Net Zero Teesside Project

The Net Zero Teesside Order

Document Reference: 7.13 Notification of Further Proposed Changes

Date: October 2022

APPENDIX 1: PLAN SHOWING REMOVAL OF EXISTING OUTFALL OPTION

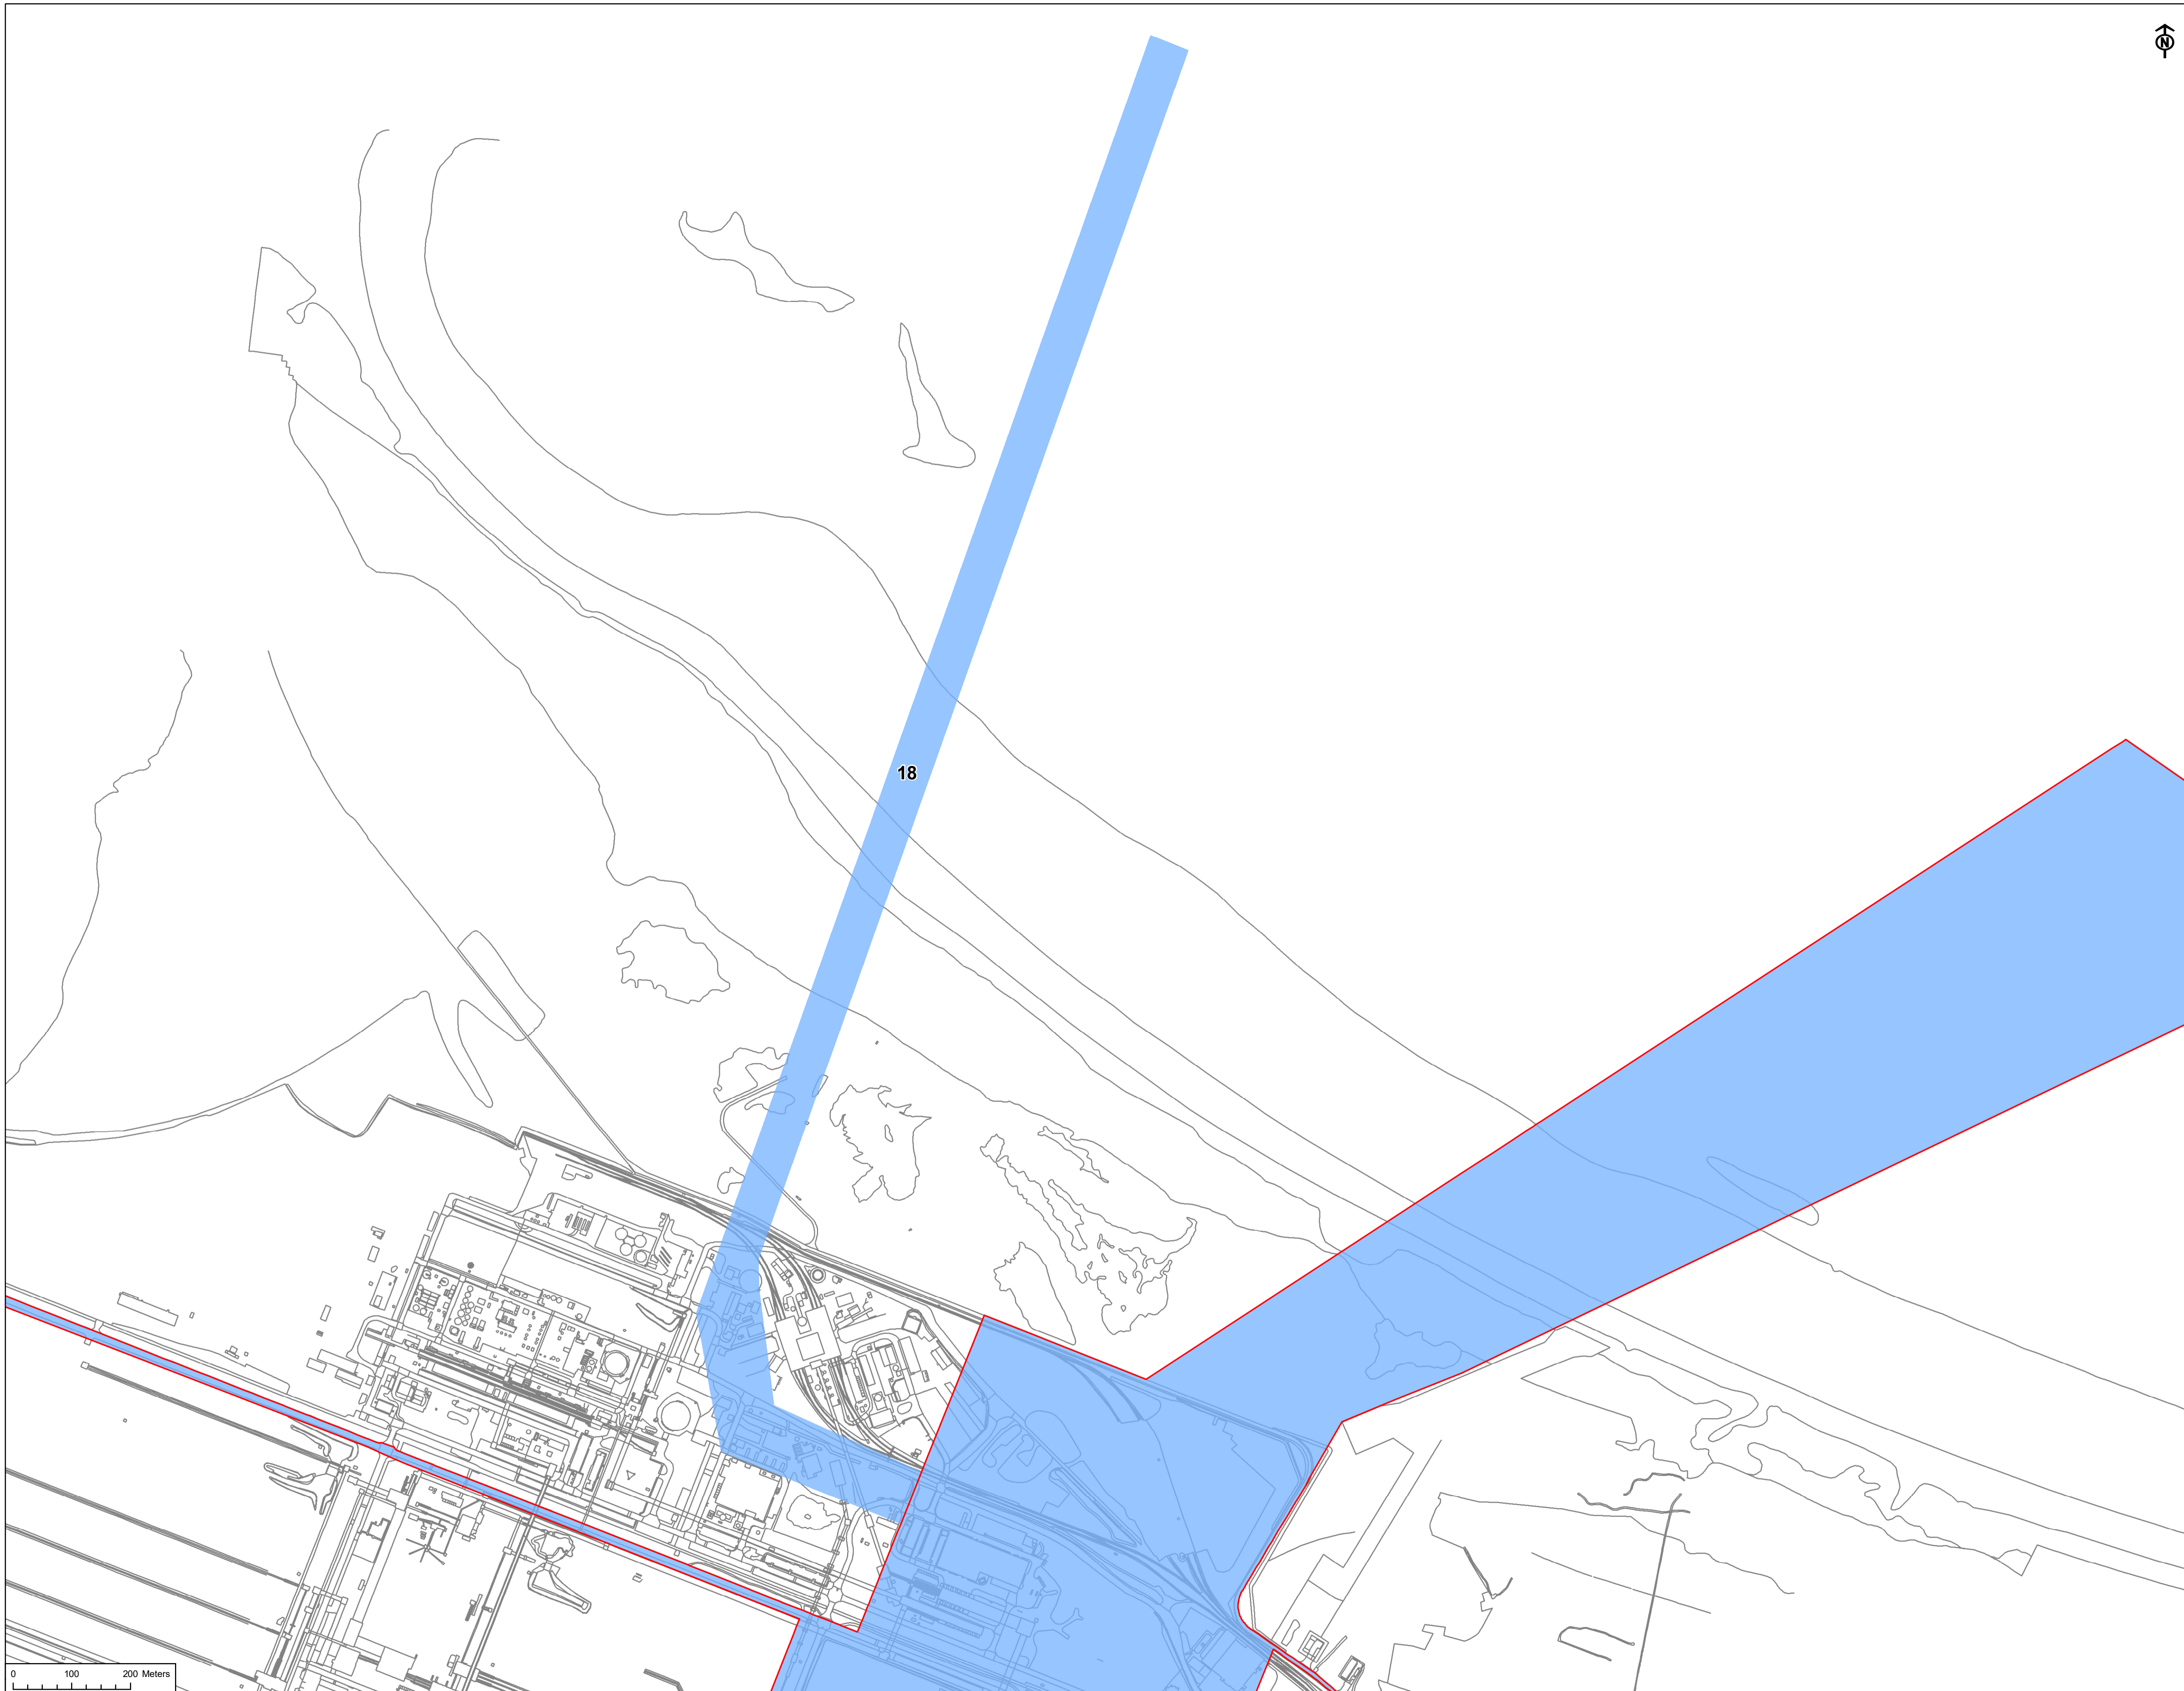
2.3.1 The Applicants confirmed during CAH3 that following completion of technical assessments, they had selected the construction of a new outfall under Work No. 5B and therefore intended to remove Work No. 5A from the Application.

2.3.2 The change request for the removal of Work No. 5A would be limited to a reduction in the Order Land/Limits and powers. The Order Land to be removed is for the sole purpose of Work No. 5A, including Plot 305, which is also covered by Work No. 10 (but solely related to activities for Work No. 5A).

2.3.4 The change request would result in the removal of complete land plots from the Book of Reference (Document Ref. 3.1), Land Plans (Document Ref. 4.2) and Crown Land Plans (Document Ref. 4.3). The impacted plot numbers are as follows:

- 297
- 304
- 305
- 306
- 307
- 308

- 310
 - 311
 - 312
 - 326
 - 371
- 2.3.5 The area land to be removed from the Application is shown on the plan at **Appendix 1**.
Tees Dock Road Access Removal

APPENDIX 2: PLAN SHOWING REMOVAL OF TEES DOCK ROAD ACCESS

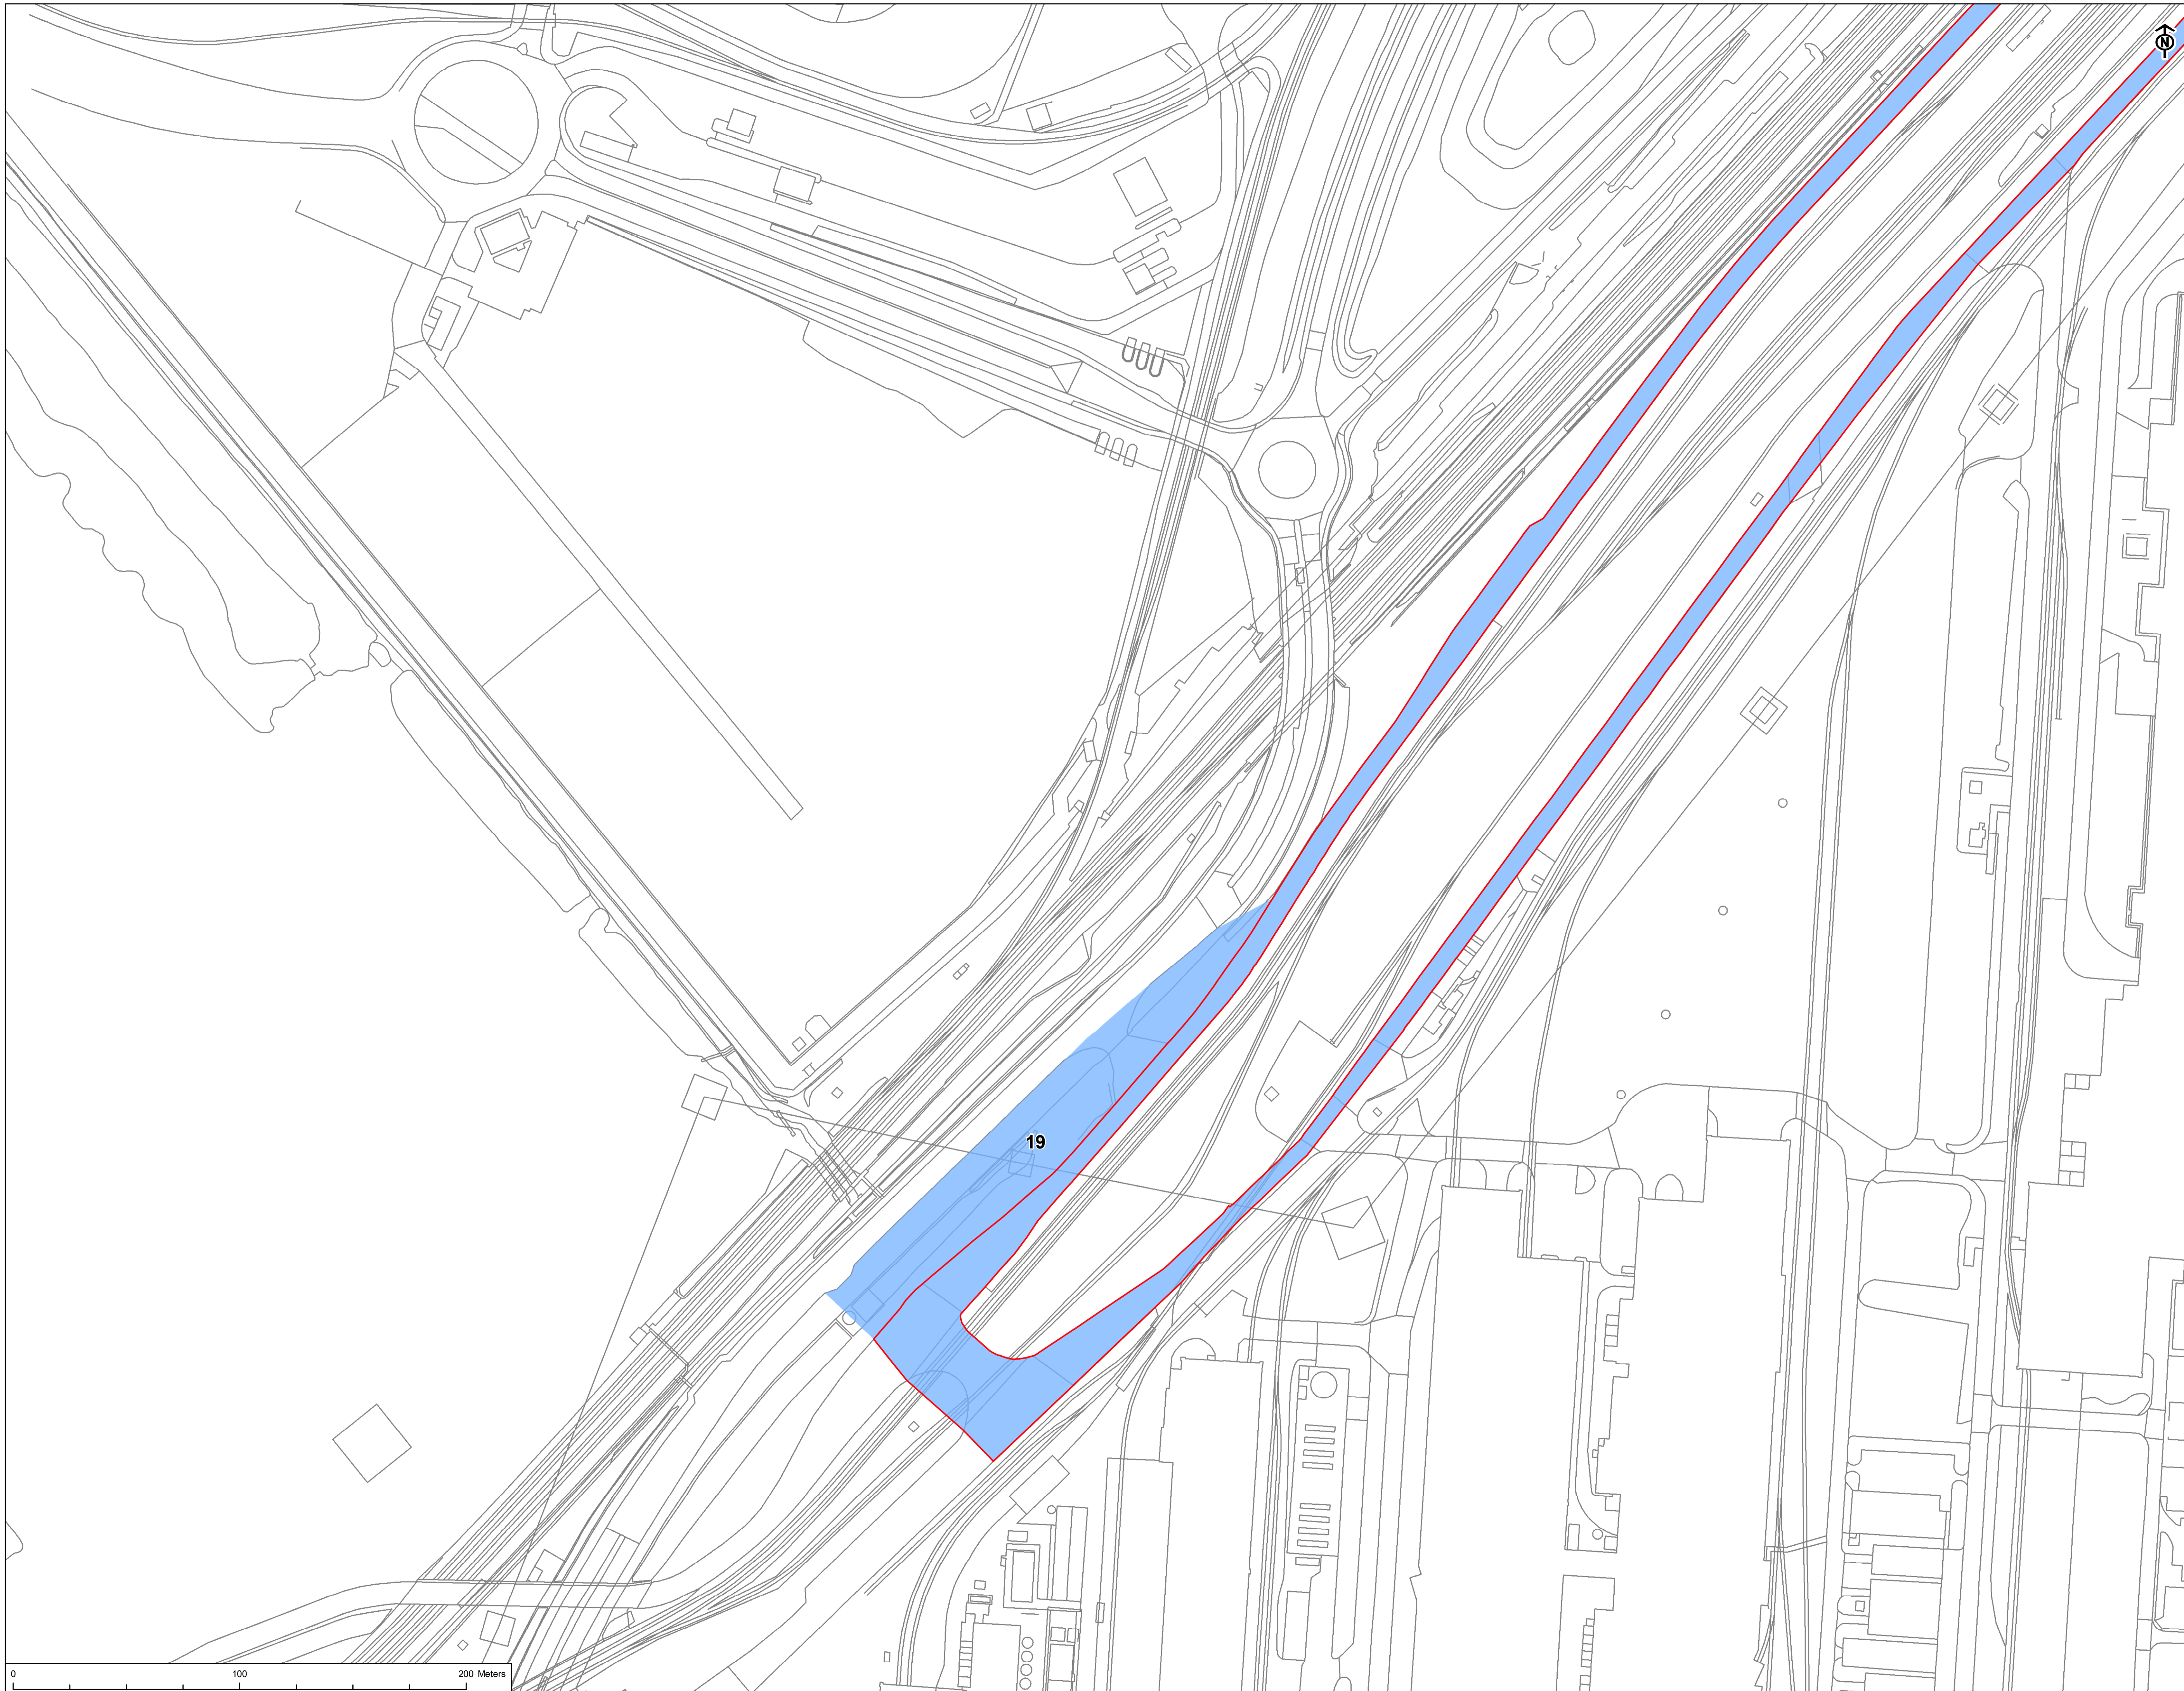
- 2.3.7 Negotiations are ongoing with STDC and therefore the Applicants are not in a position to remove the Tees Dock Road Access plots from the Application at this stage. However, the Applicants intend to request that the relevant plots be removed from the Application upon securing the alternative Lackenby Steelworks Gate Access Route via a legal agreement with STDC, but consider this is now likely to fall after the end of the Examination.

- 2.3.8 The change request for the removal of the Tees Dock Road Access would be limited to a reduction in the Order Land/Limits and powers. The areas which would be removed relate solely to Work No. 10.

- 2.3.10 The Applicants have engaged with STDC on the extent of the change and have agreed the Order Land that would be removed if the change was brought forward by the Applicants. In summary, all of Plot 274 and part of Plot 279 would be removed.

- 2.3.12 The area land that would be removed from the Application is shown on the plan at **Appendix 2**.
- 2.4 **Potential Changes to the Environmental Statement**
Wastewater Outfall Selection
